Project	IEEE 802.16 Broadband Wireless Access Working Group < http://ieee802.org/16 >
Title	Harmonized Relay Frame Structure
Date Submitted	2009-01-15
Source(s)	<p>Jerry Sydir, Alexander Maltsev, Honggang Li, Alexei Davydov, Rui Huang Intel Corporation jerry.sydir@intel.com</p> <p>Rakesh Taori, Youngbin Chang Samsung Electronics rakesh.taori@samsung.com</p> <p>Shashikant Maheshwari, Adrian Boariu, Yousuf Saifullah Nokia Siemens Networks shashi.maheshwari@nsn.com</p> <p>Li-Hsiang Sun , Ki-Dong Lee, Aeran Youn LG Electronics lsun@lge.com</p> <p>Yuqin Chen, Yang Liu, Hongyun Qu, Mary Chion ZTE Corporation chen.yuqin@zte.com.cn liu.yang8@zte.com.cn qu.hongyun@zte.com.cn mchion@zteusa.com</p> <p>Jungnam Yun, Yerang Hur, Bong Ho Kim POSDATA Co., Ltd. jnyun@posdata-usa.com</p> <p>Fang-Ching (Frank) Ren, Richard Li ITRI frank_ren@itri.org.tw richard929@itri.org.tw</p> <p>*<http://standards.ieee.org/faqs/affiliationFAQ.html></p>

Re:	TGm SDD CfC (IEEE 802.16m-08/052) – Section 14.4.4
Abstract	This contribution proposes a harmonized relay frame structure which combines features of the option 1 and 2 frame structures.
Purpose	For consideration and adoption into the 16m SDD document.
Notice	<i

Figure 33 Relay Frame structure ~~option 1~~

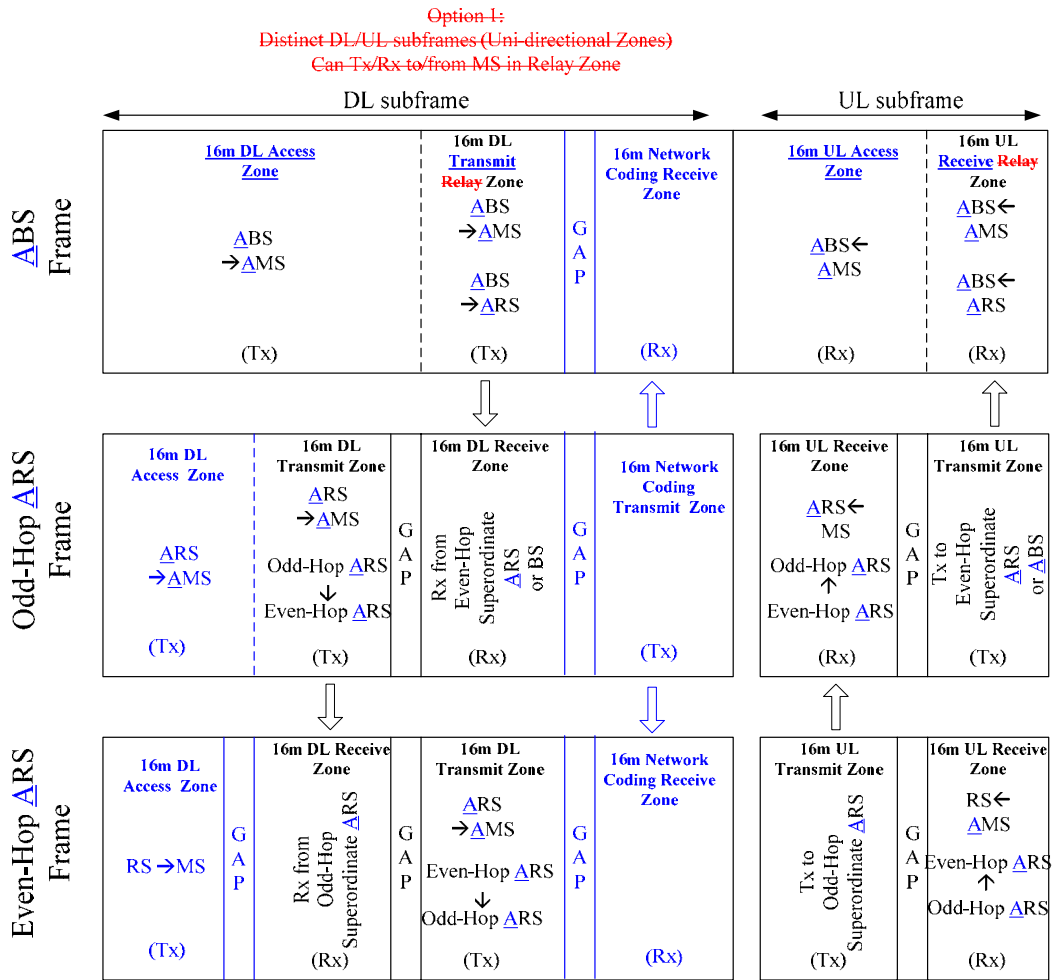
~~There are two options for the Relay frame structure. These are captured in Figure 33 and Figure 34. Further study is required to distill a single frame structure from among these two options. The Relay frame structure is illustrated in Figure 33.~~

[Modify figure 33 on page 68 as indicated below]

[Modify the caption of figure 33 on page 68 as indicated below]

- DL Access Zone: An integer multiple of subframes located in the Mzone of the DL of the ABS frame or ARS frame, where a ABS or an ARS can transmit to the AMSs. SCH and BCH as well as unicast transmissions may be performed in this zone.

- DL Transmit Zone: An integer multiple of subframes located in the Mzone of the DL of the ABS frame or 16m ARS frame, where an ABS or ARS can transmit to subordinate ARSs and the AMSs.

- DL Receive Zone: An integer multiple of subframes located in the Mzone of the DL of the ARS frame, where an ARS can receive from its superordinate station.

- UL Transmit Zone: An integer multiple of subframes located in the Mzone of the UL of the ARS frame, where a ARS can transmit to its superordinate station.
- UL Receive Zone: An integer multiple of subframes located in the Mzone of the UL of the ABS frame or ARS frame, where a ABS or ARS can receive from its subordinate ARSs and the AMSs.
- Network Coding Transmit Zone: An integer multiple of subframes located in the DL of the frame of the Odd Hop ARS which is directly attached to the ABS, where an Odd Hop ARS can transmit network coded transmissions to the ABS and Even Hop ARS. Transmissions to the AMS in this zone are FFS.
- Network Coding Receive Zone: An integer multiple of subframes located in the DL of the ABS or Even Hop ARS frame, where an ABS or Even Hop ARS can receive network coded transmissions from the Odd Hop ARS.
